Manual 07 Update – Revision 5

PJM Protection Standards

Stan Sliwa, P.E.
Transmission Planning
Planning Committee
July 8, 2025

Transformer High-Side Lead Protection Examples

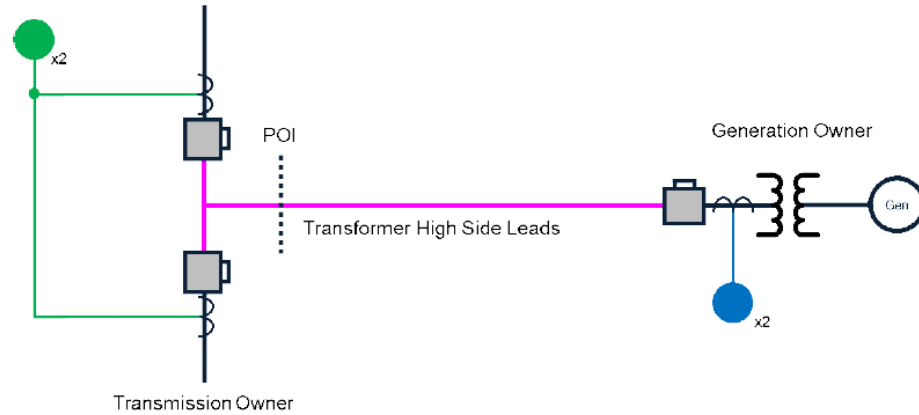
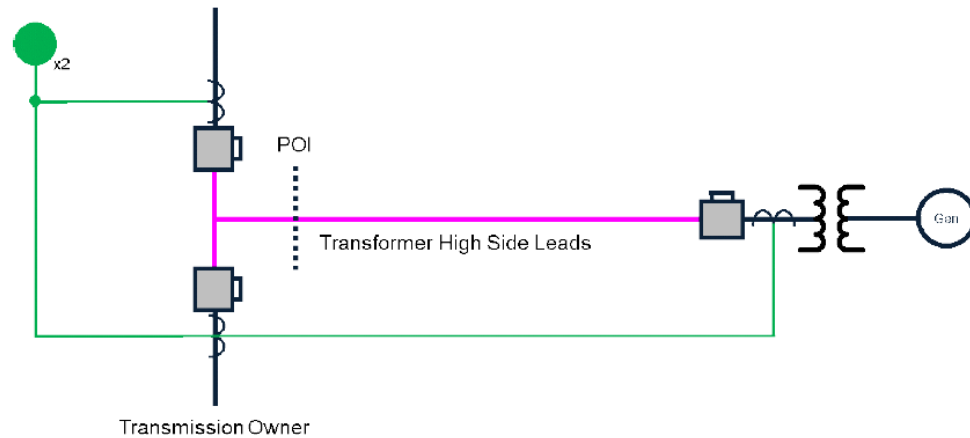
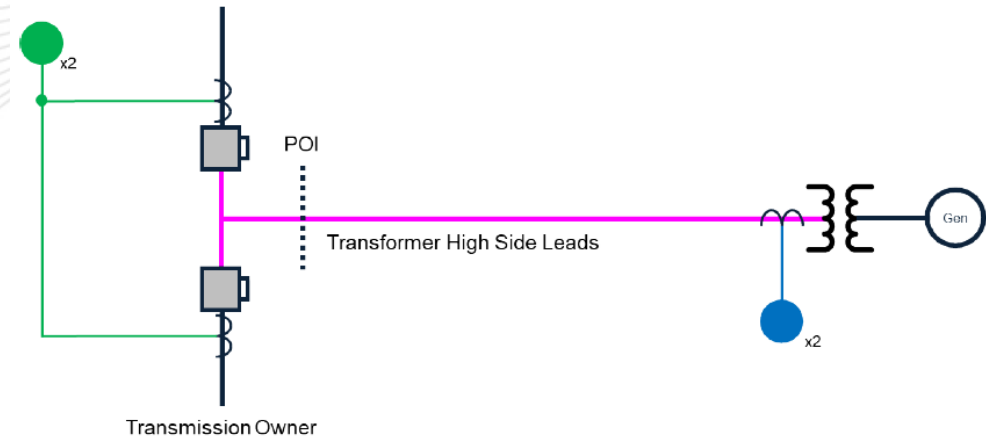
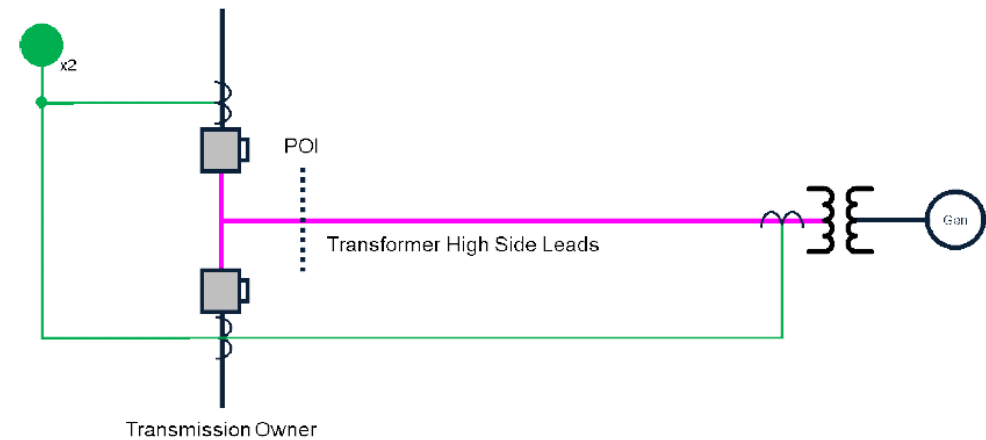
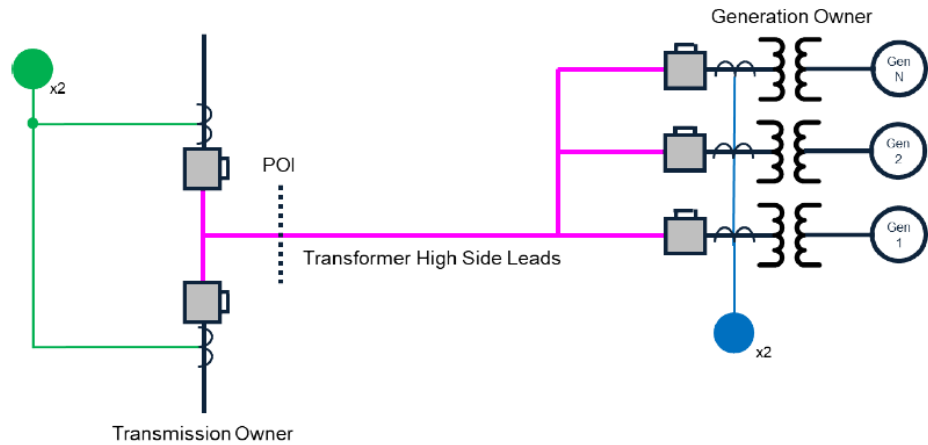
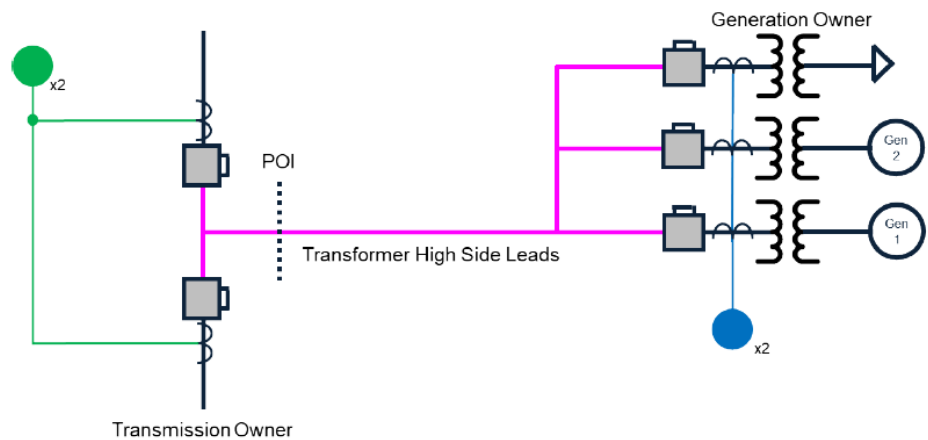
- Enhanced section 4.2 on transformer high-side lead protection with more details and added reference diagrams

The transformer high-side leads are required to be protected by two independent current differential schemes ~~or equivalent high-speed schemes~~. The schemes must utilize independent current sources and independently protected DC control circuits.

Transformer high-side leads shall not have infeed within the protection zone as experienced by the two independent current differential schemes. Transformer high-side leads shall not have more than two terminals as experienced by the two independent current differential schemes.

In Section 4.2.1 several examples of acceptable configurations are provided; this is not an exhaustive list. Other configurations of both the protection and phase conductor are possible while satisfying the requirements. Additionally, Section 4.2.1 provides a possible system configuration that is prohibited.
